August 2, 2000
NRC-00-0046

Subject: Response to Request for Additional Information
on Technical Specifications Change Request Related to
Spent Fuel Pool Expansion at Fermi 2 (TAC No. MA7233)

**RESPONSE TO REQUEST FOR ADDITIONAL INFORMATION ON
TECHNICAL SPECIFICATIONS CHANGE REQUEST RELATED TO SPENT FUEL
POOL EXPANSION AT FERMI 2**

(Marked up UFSAR Figures 12.1-6, 12.1.7-Sheet 1 and 12.1-8)

FIGURE 12.1-6
FERMI 2 RADIATION ZONES—THIRD FLOOR PLAN

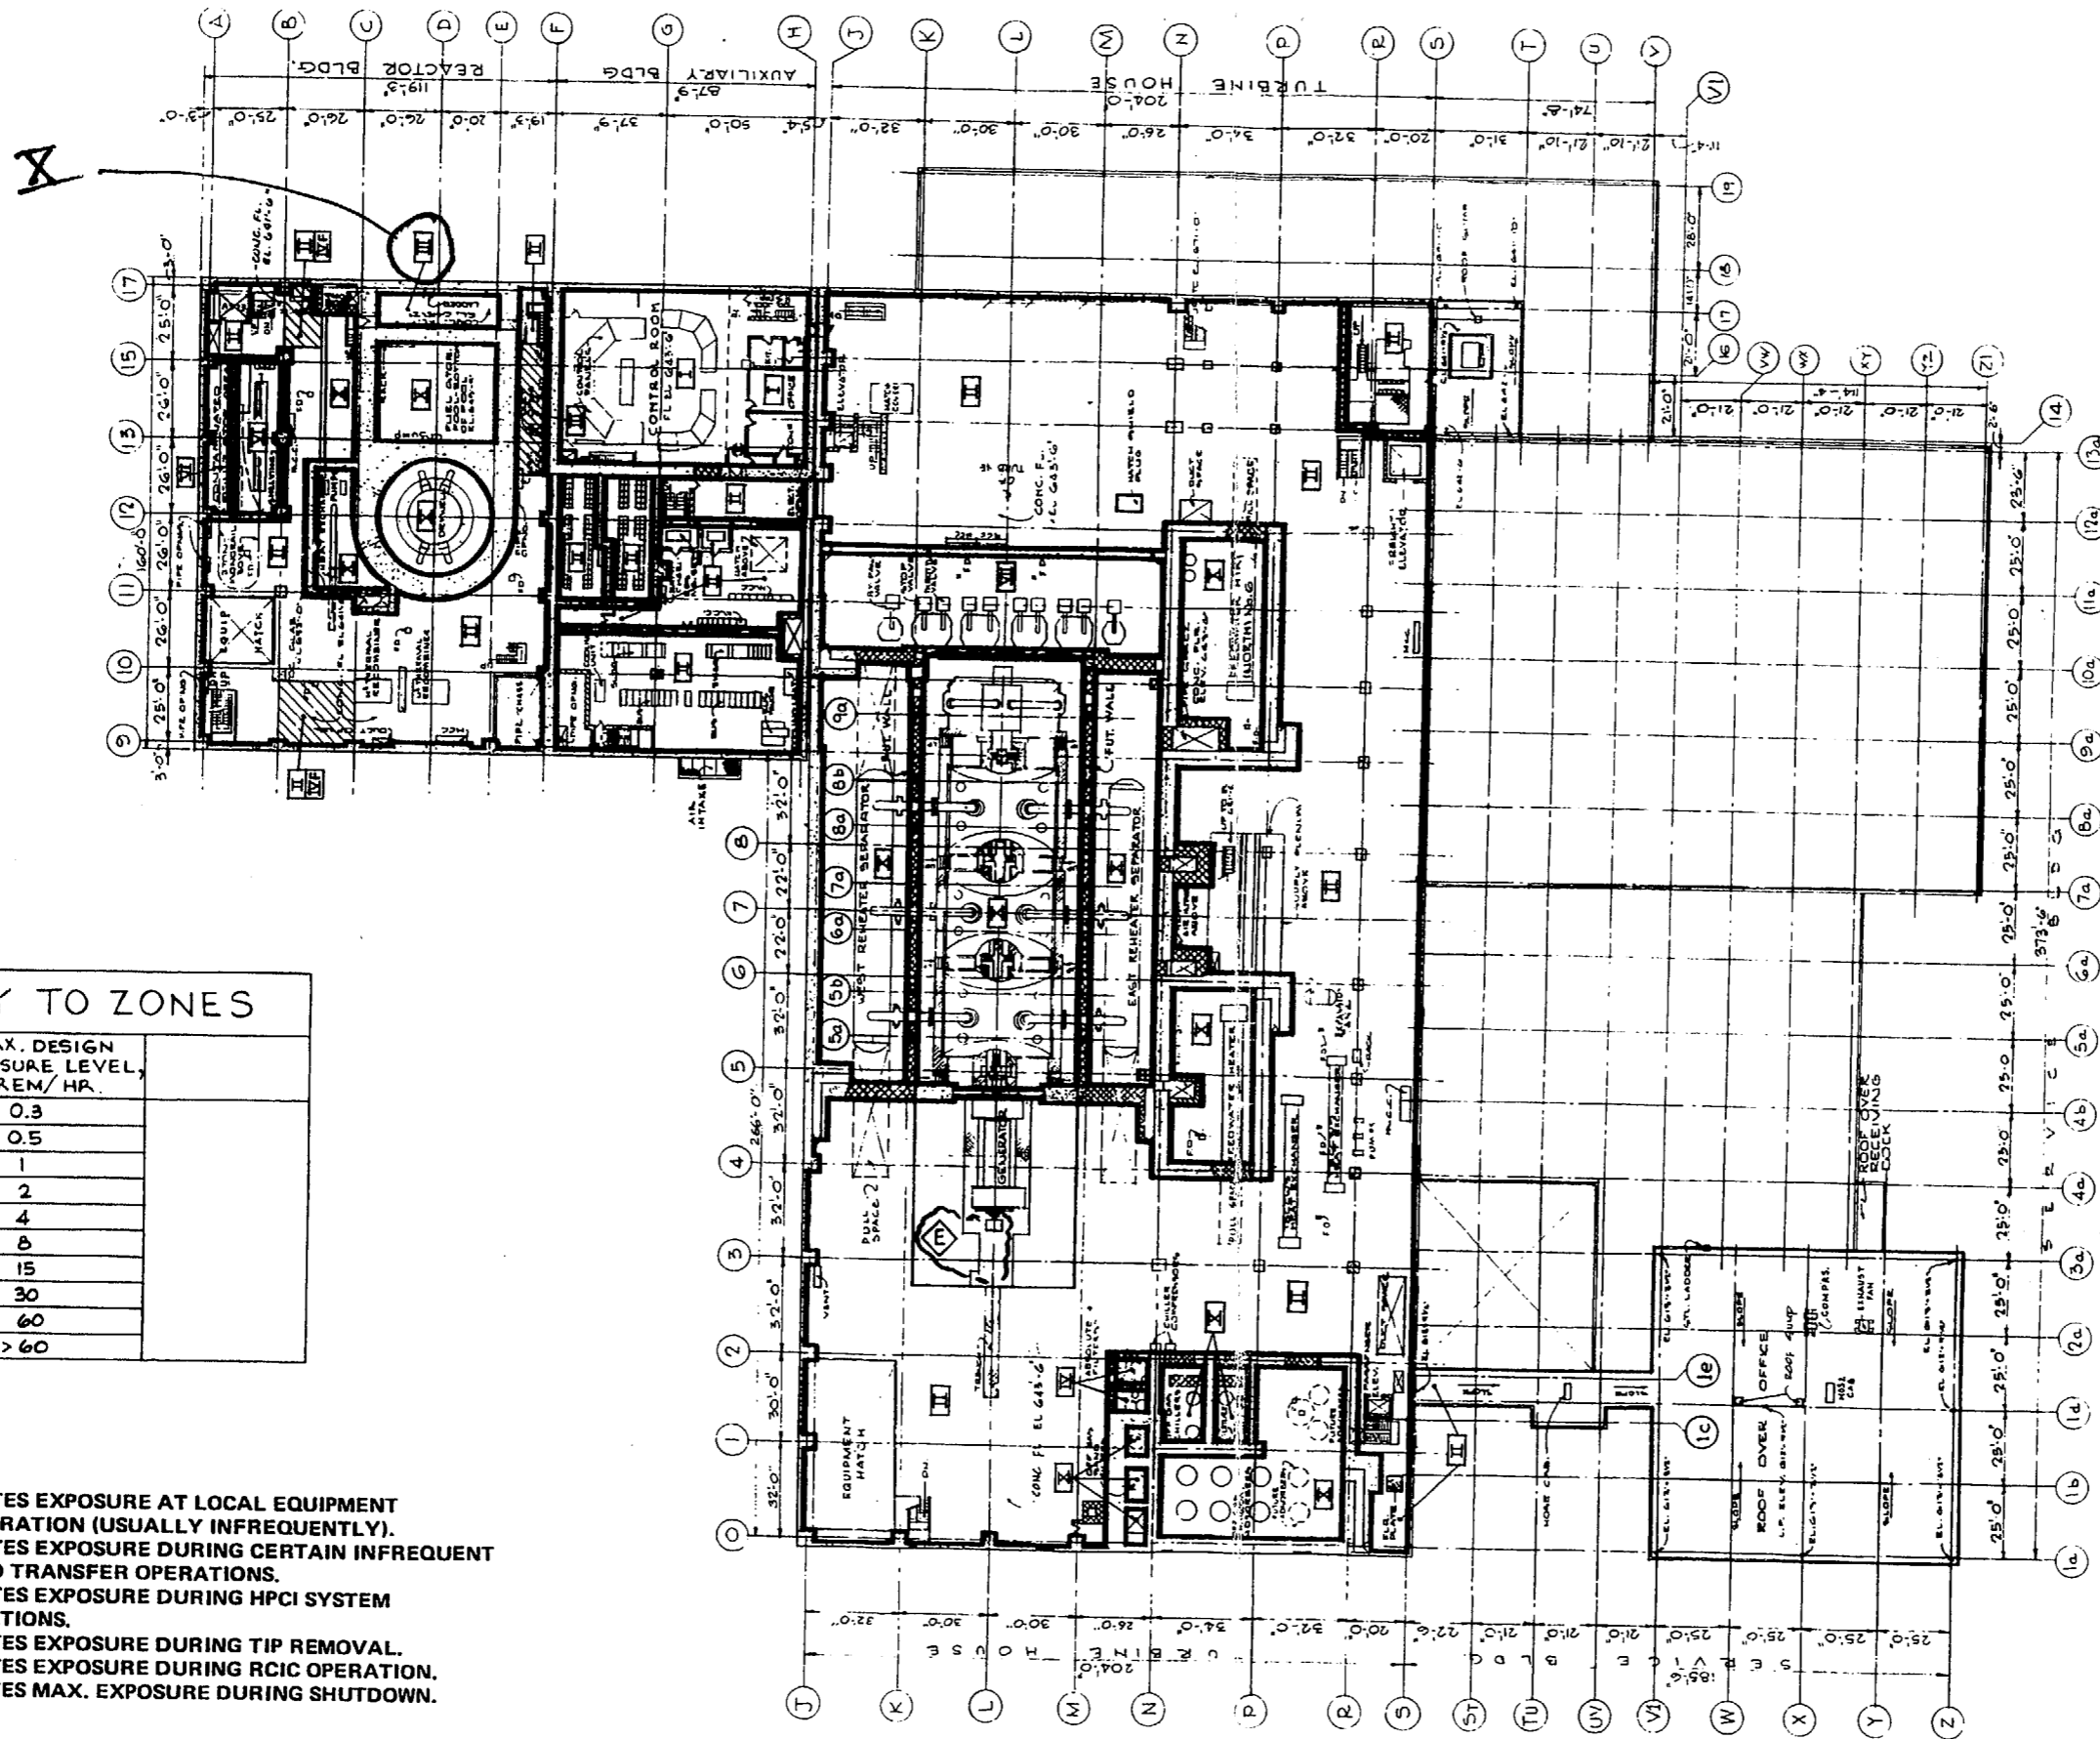
In UFSAR Fig. 12.1-6 ("Third Floor"), for the area north of the Spent Fuel Pool north wall:

Change Zone from III to X.

FIGURE 12.1-7, SHEET 1

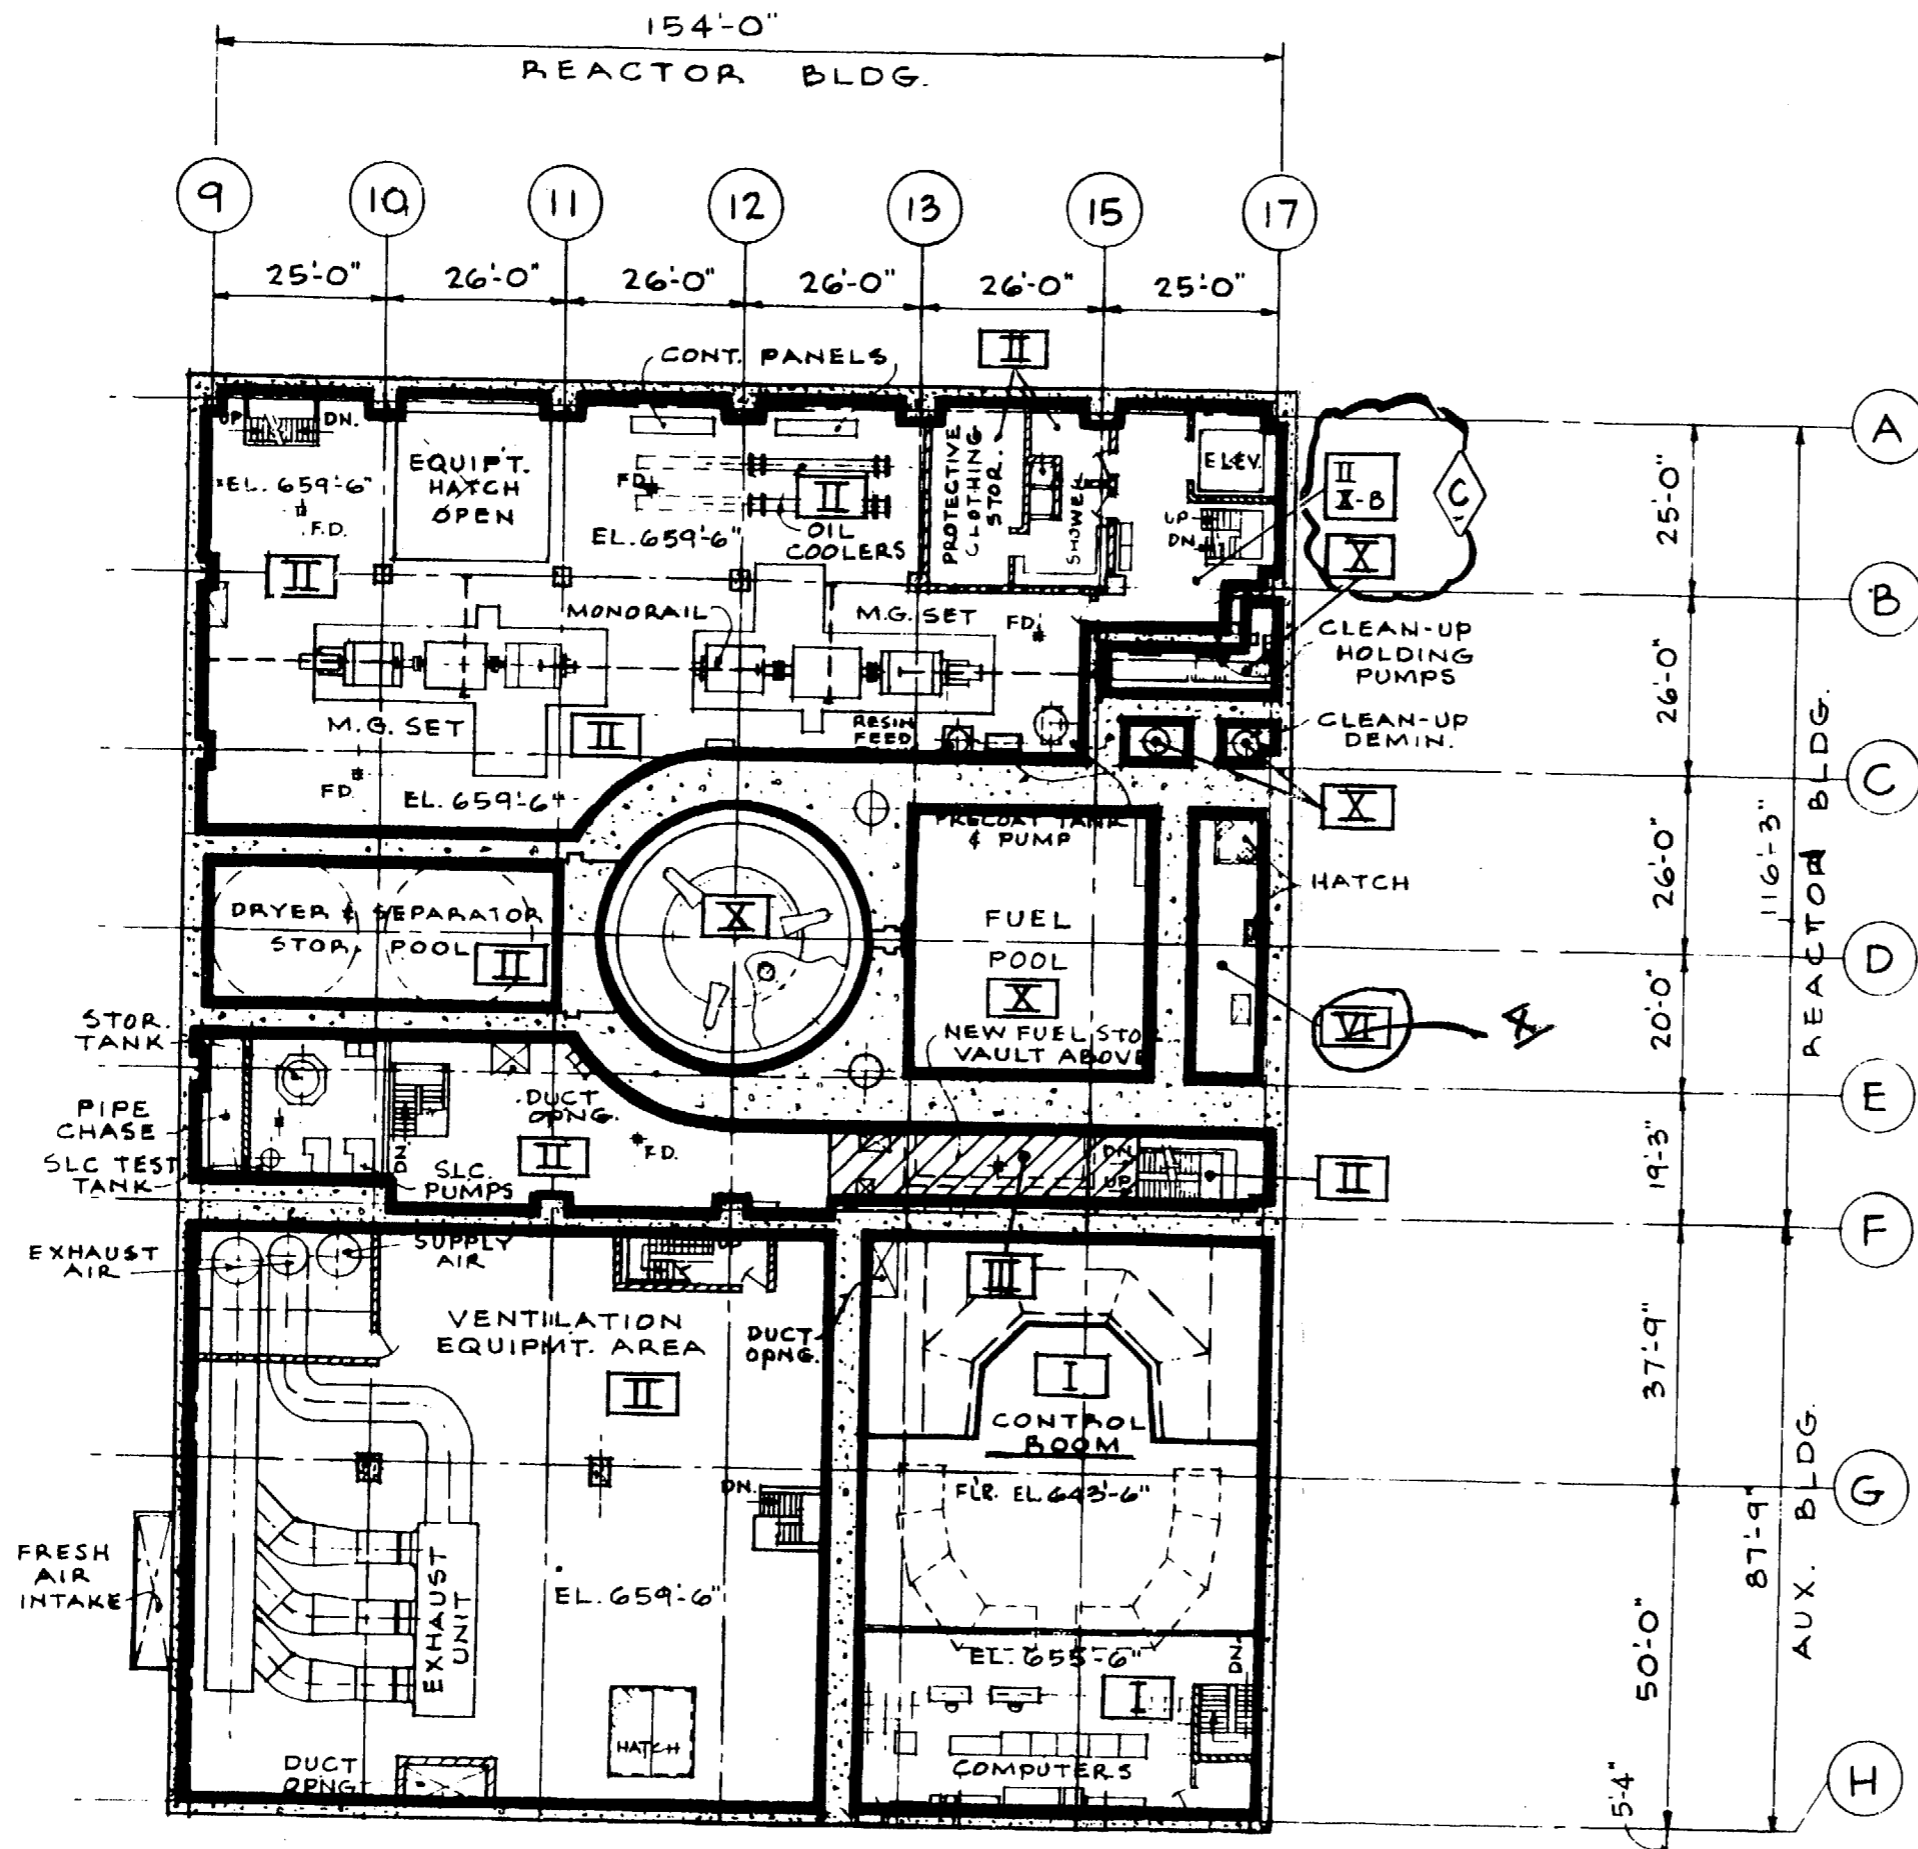
In UFSAR Fig. 12.1-7, Sheet 1 ("Fourth Floor"), for the area north of the Spent Fuel Pool north wall:

Change Zone from VI to X.

FIGURE 12.1-8
FERMI 2 RADIATION ZONES – FIFTH FLOOR PLAN

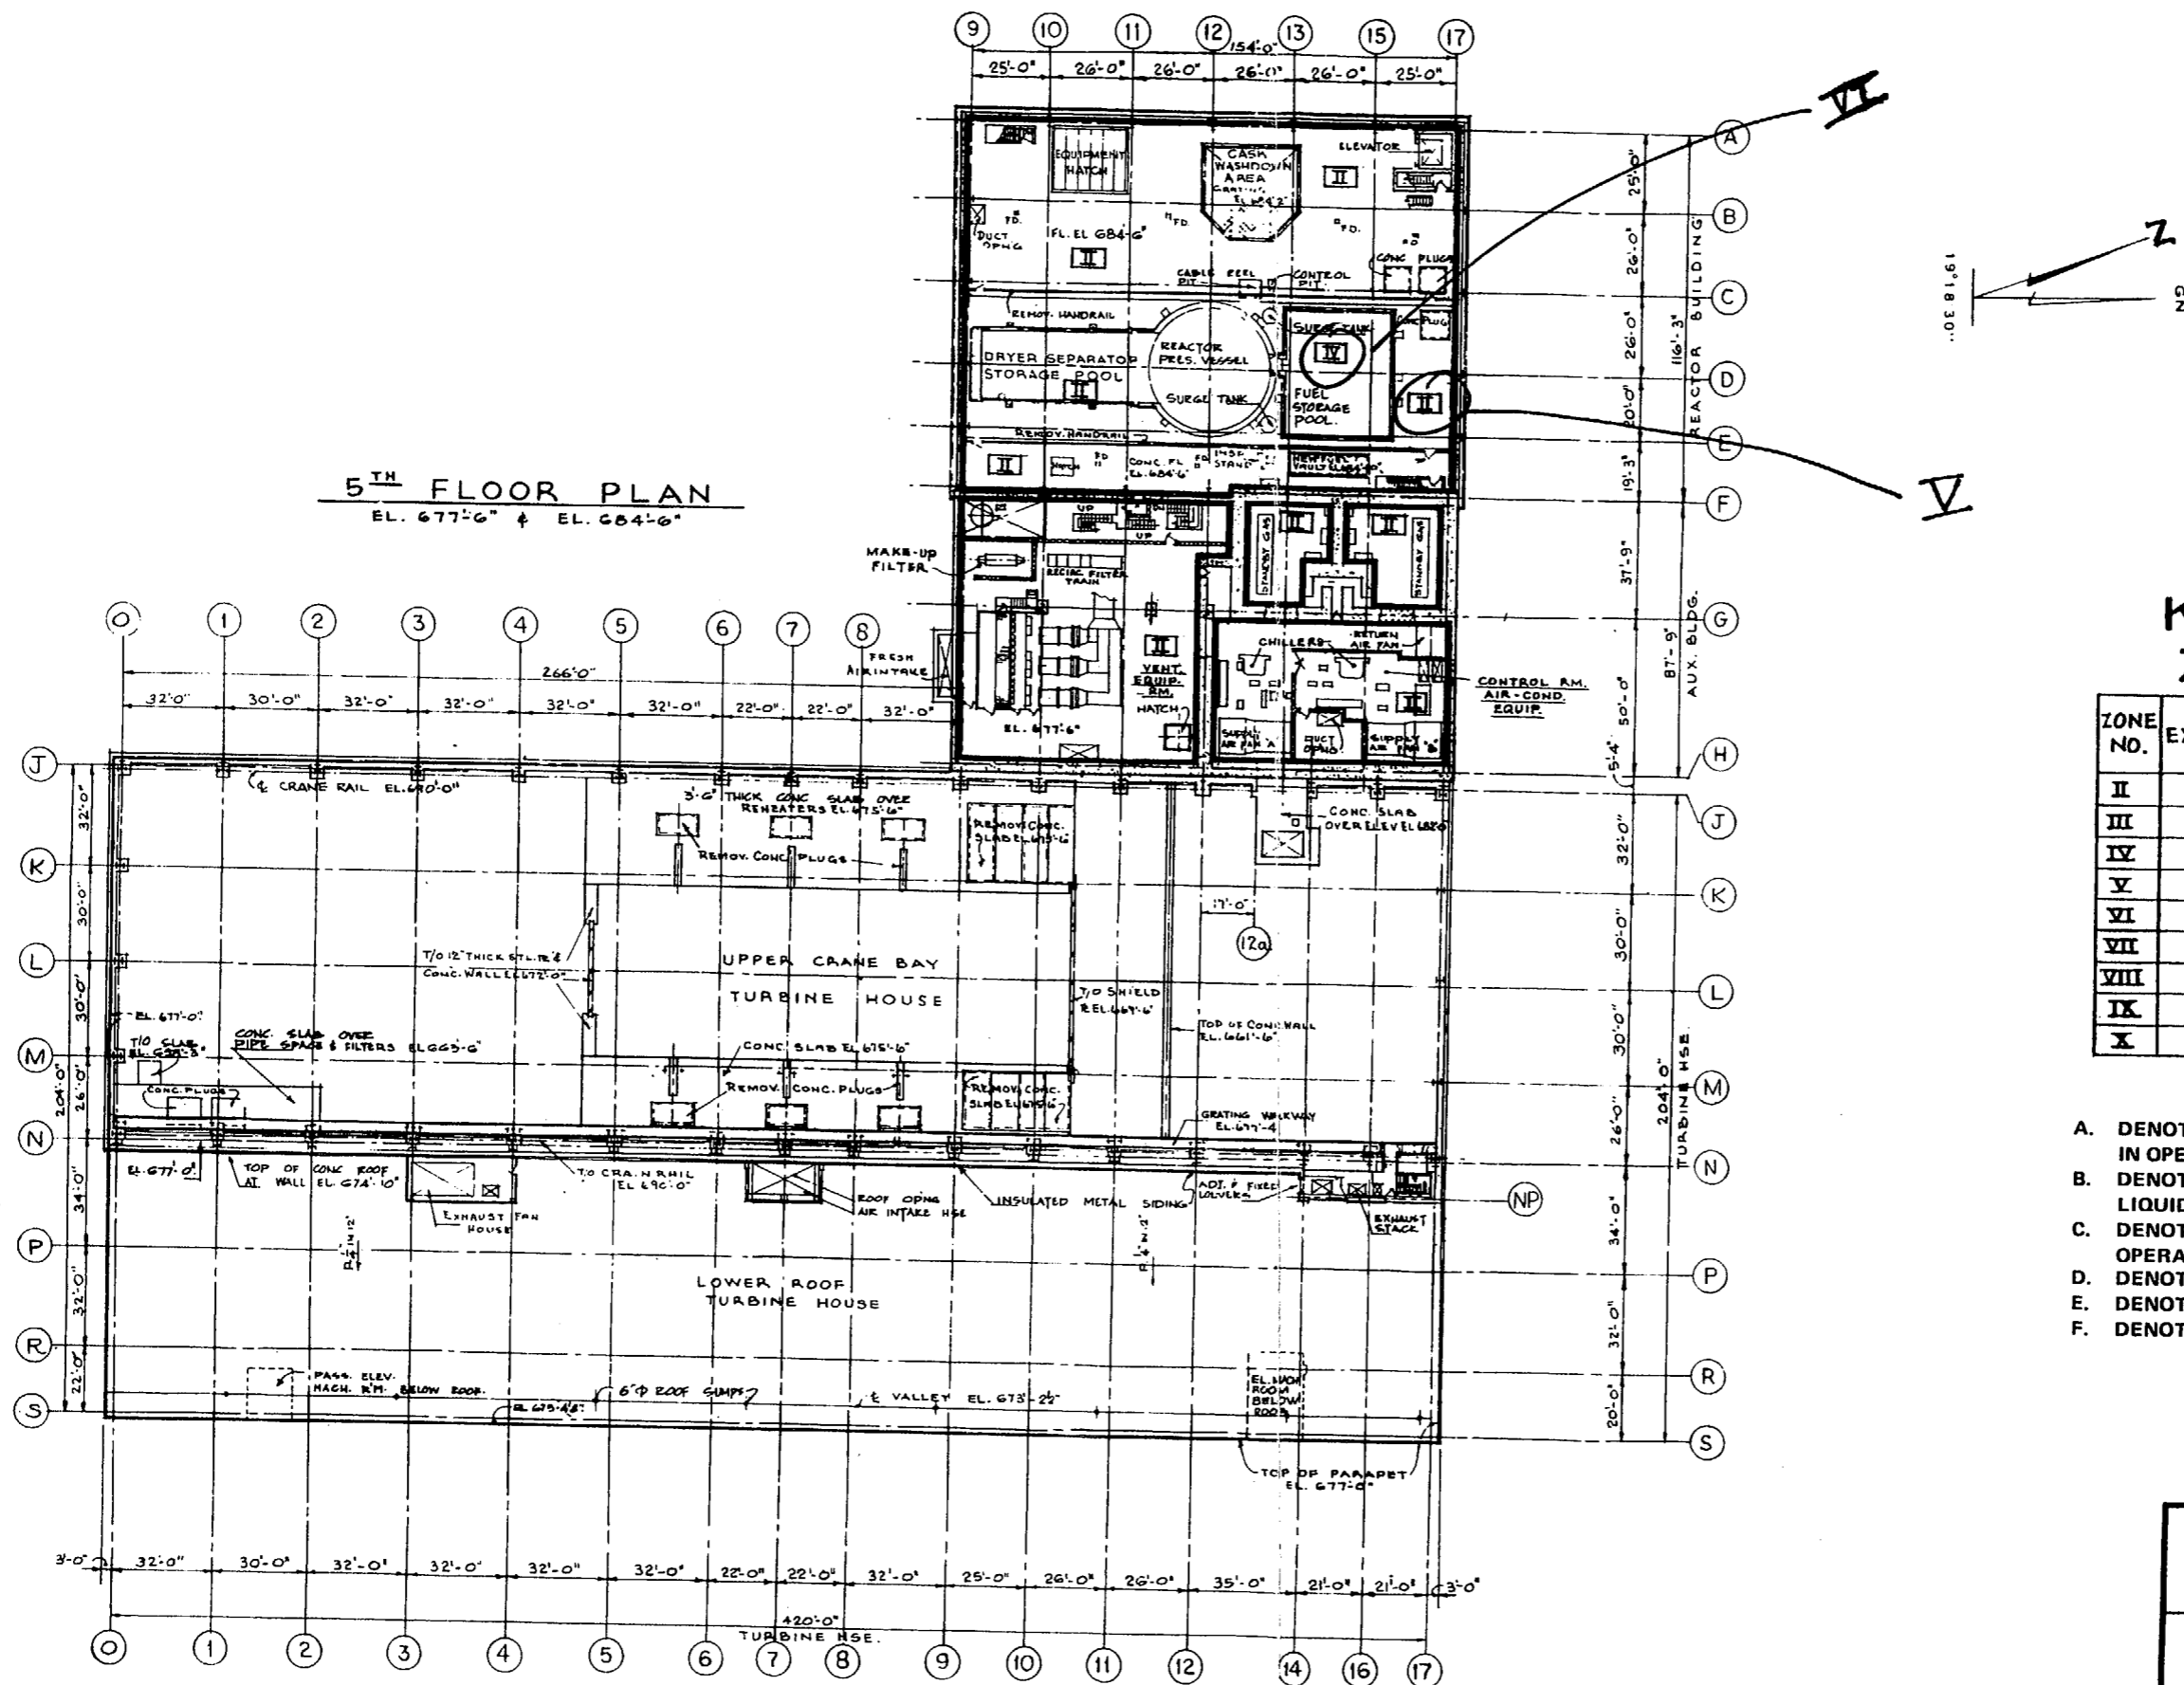
In UFSAR Fig. 12.1-8 ("Fifth Floor"), for the area above the Spent Fuel Pool:

In UFSAR Fig. 12.1-8 ("Fifth Floor"), for the Spent Fuel Pool deck:

Change Zone from IV to VI.

Change Zone from II to V.
